revision:	date:	note:
P01	20190425	planning submission
P02	20190607	signage zones and indicative design included
P03	20201211	non-material amendment
P04	20210113	section 73 application

project
4*hotel on princess street, manchester
job no.
7415
title
proposed princess street elevation
scale
1:200 @ A3
drawing no.
al(05)0030

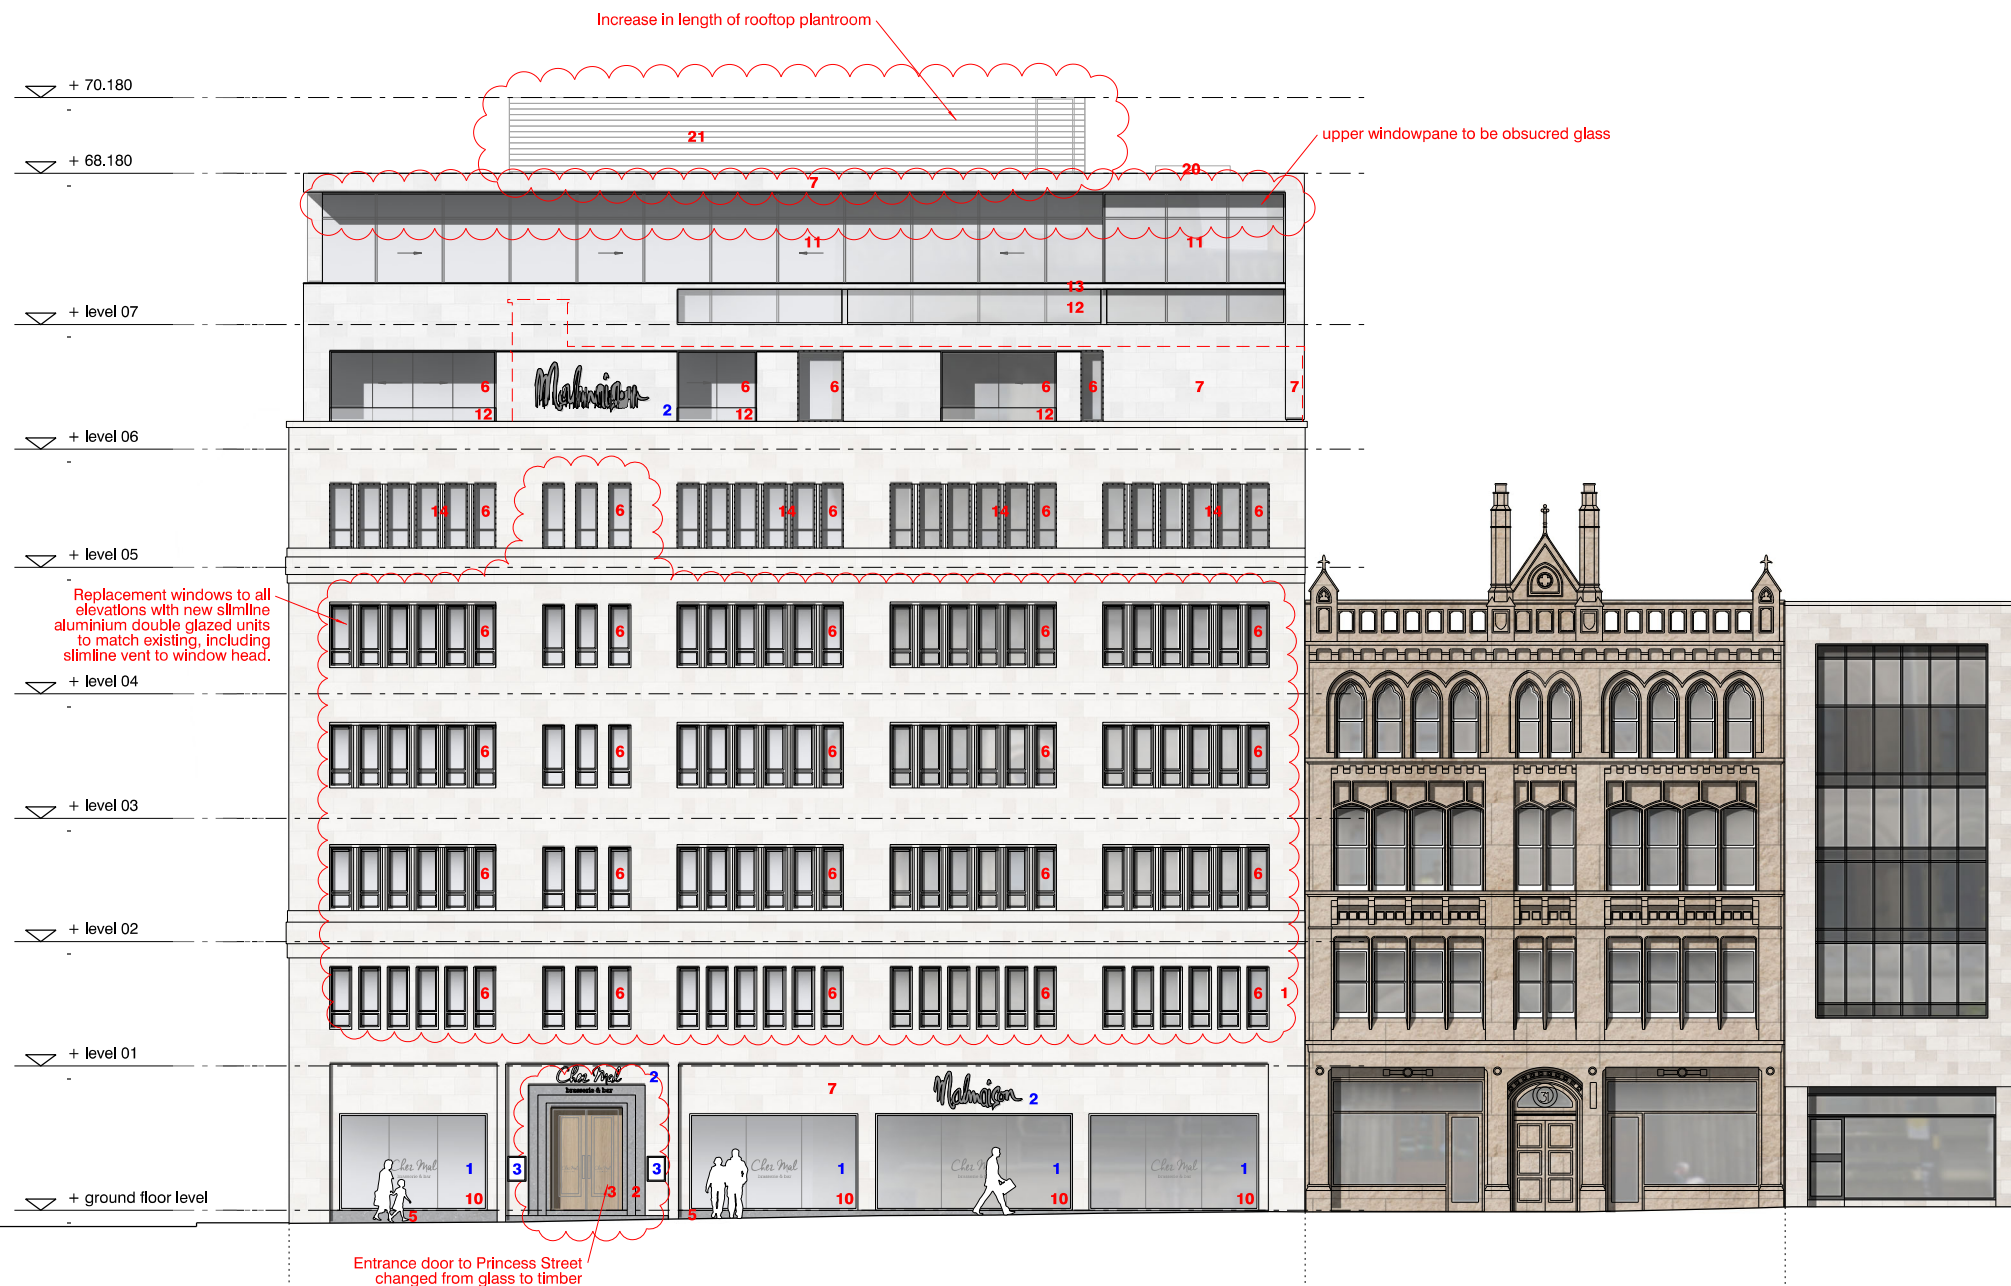
- 3. new timber panelled entrance door
- 4. omitted
- 6. new slimline aluminium windows & doors with slimline vent to head, to match existing window profiles (35mm). colour to be dark grey
- 9. new brickwork to be painted with mineral, masonry, matt paint. colour to match existing portland and new natural stone
- 14. new natural stone mullions and/or intermediate transoms to match existing portland stone

• denotes amended description
